CITY OF ALBUQUERQUE

RE: **Lot 33 Block 8 Unit 22
Volcano Cliffs SAD 228
6431 Picardia Rd. NW
Grading and Drainage Plan
Engineers Stamp Date 9/19/19 (D10D003E37)
Pad Certification Dated 5/22/2020**

DRAINAGE AND TRANSPORTATION INFORMATION SHEET (REV 6/2018)

ENGINEER'S SEAL 9/19/19 DAVID SOULE P.E. #14522	6431 PICARDIA GRADING AND DRAINAGE PLAN 1606 CENTRAL AVENUE SE SUITE 201 ALBUQUERQUE, NM 87106 (505) 872-5998	DRAWN BY: WCMJ
		DATE: 9-19-19 2109078-LAYOUT-9-19-19 SHEET # JOB # 2109076

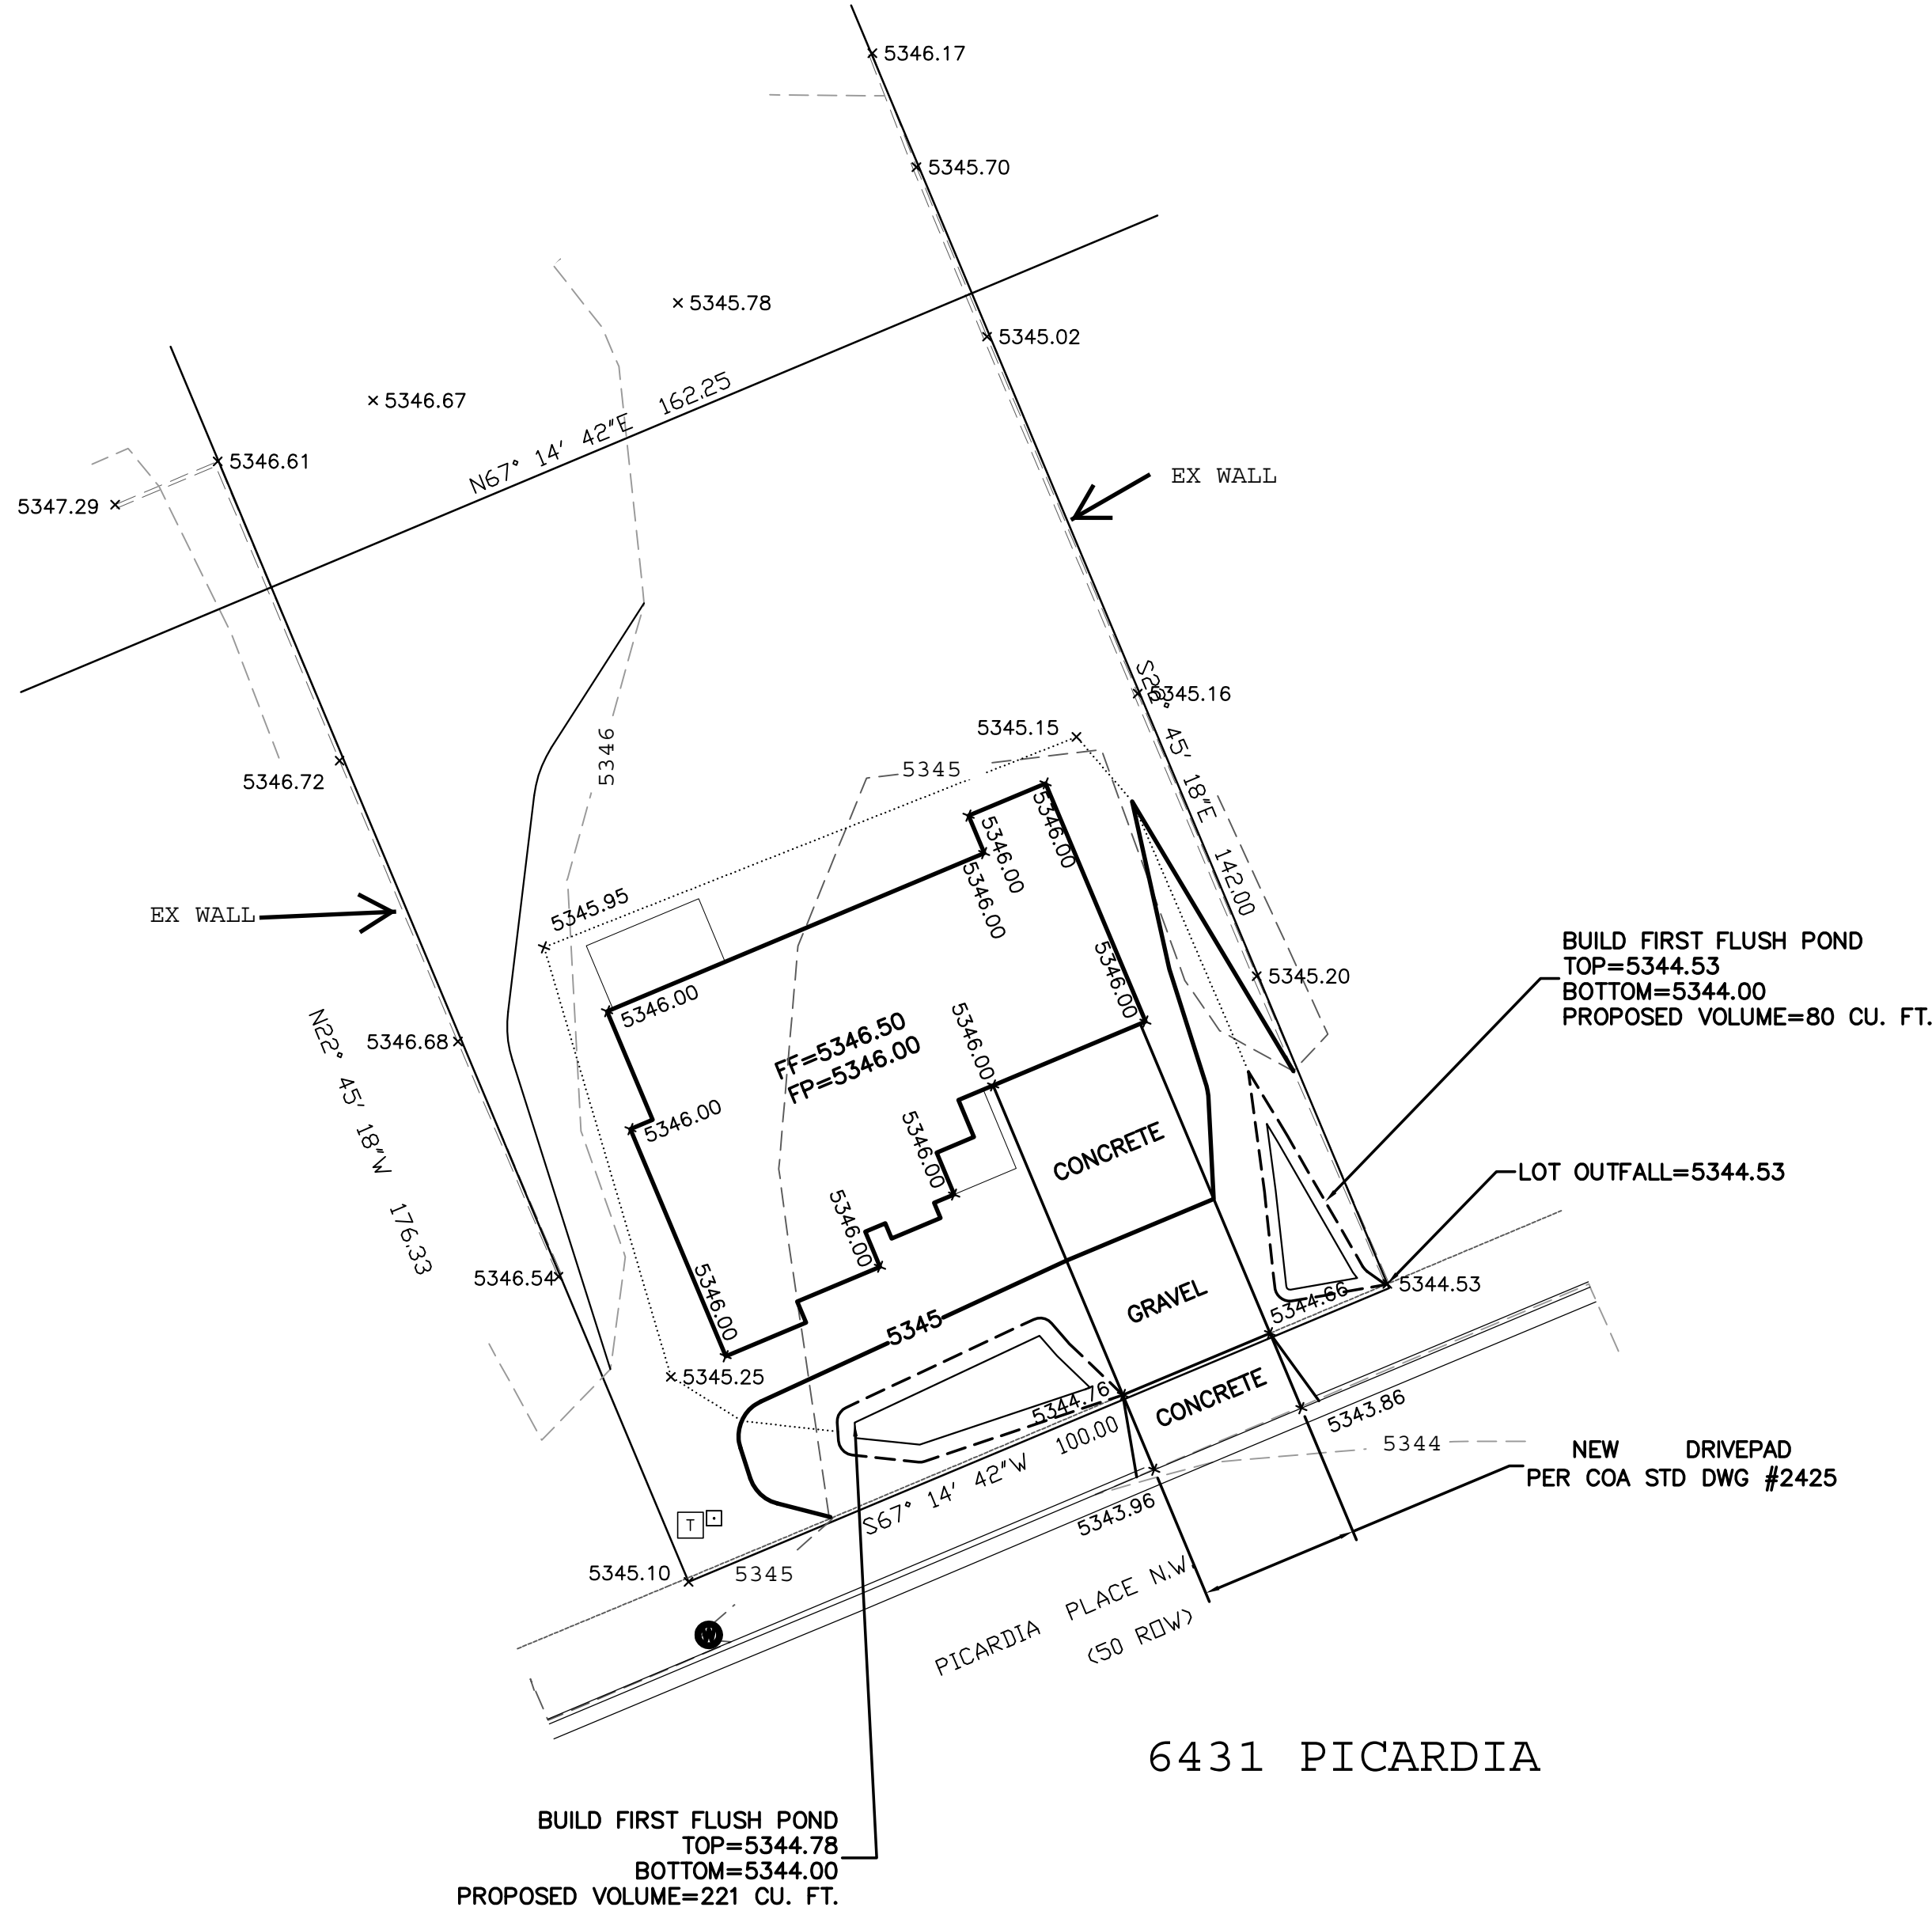
Based upon the information provided in your submittal received 5/27/2020, this plan is approved for Building Permit.

Please inform the builder to attach a copy of this approved plan to the construction sets in the permitting process prior to sign-off by Hydrology. Also, notify the owner/contractor that a separate permit for any garden wall or fencing is required, and this is the plan to be used for the placement of said fence.

Prior to Certificate of Occupancy release, Engineer Certification per the DPM checklist of this plan will be required.
